**CBER CMC BLA Resubmission Review Memorandum
Complete Response**

BLA STN 125807/57

**ZEVASKYN
Prademagene zamikeracel**

Figure 2 - Carton Label for P1-P3 and P4 Packaging

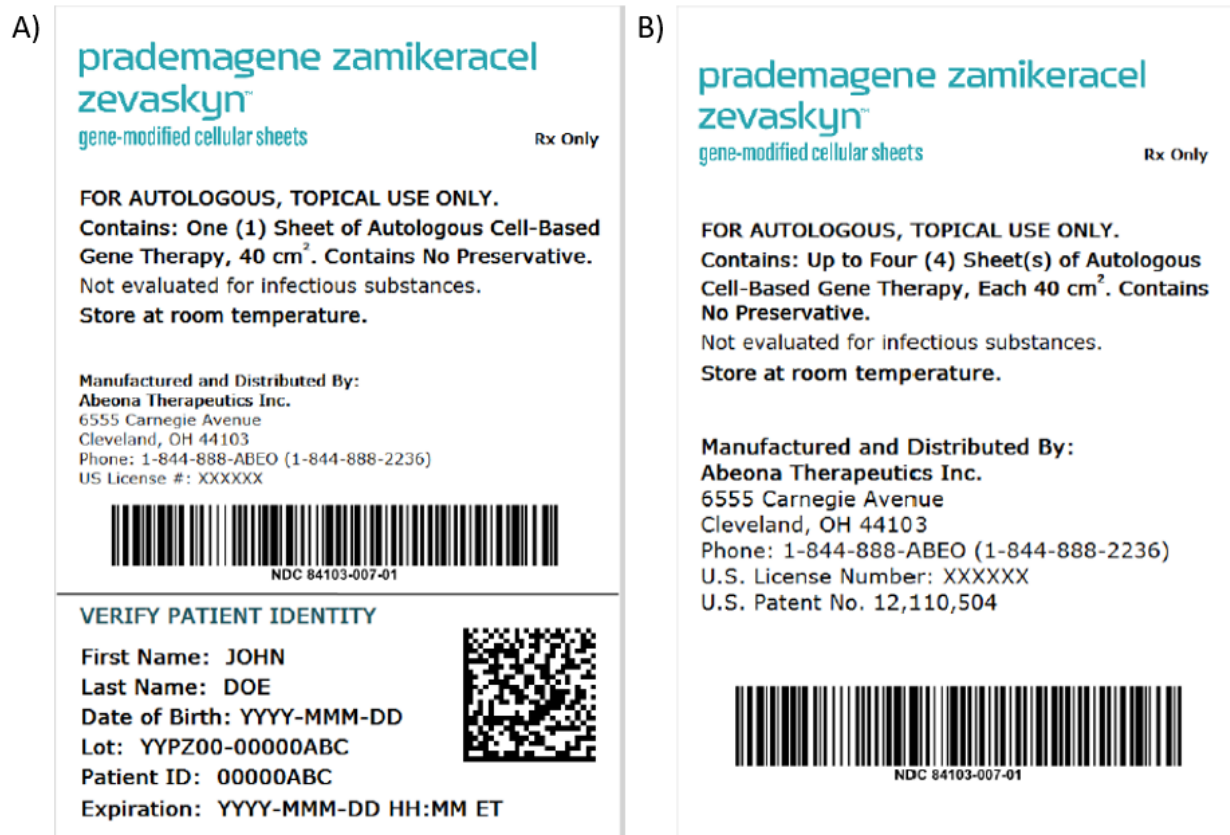
Figure 2. shows the final carton labels for P1-P3 and P4 were submitted under Amendment 69 on March 12, 2025 after several rounds of IRs (IR #47, Regulatory IR

#6, Amendment 64; IR #52, CMC IR #17, Amendment 69; CMC IR #21 Amendment 79). The applicant made necessary revisions to the carton label to follow 21 CFR 610.62 with regard to name placement, prominence, layout, and crowding. A) Depiction of Carton label for P1-P4 packaging. B) Depiction of outermost packaging carton label.

Reviewer Comment (BNN): After several IR communications, the applicant revised the carton labels adequately per 21 CFR 610.62.
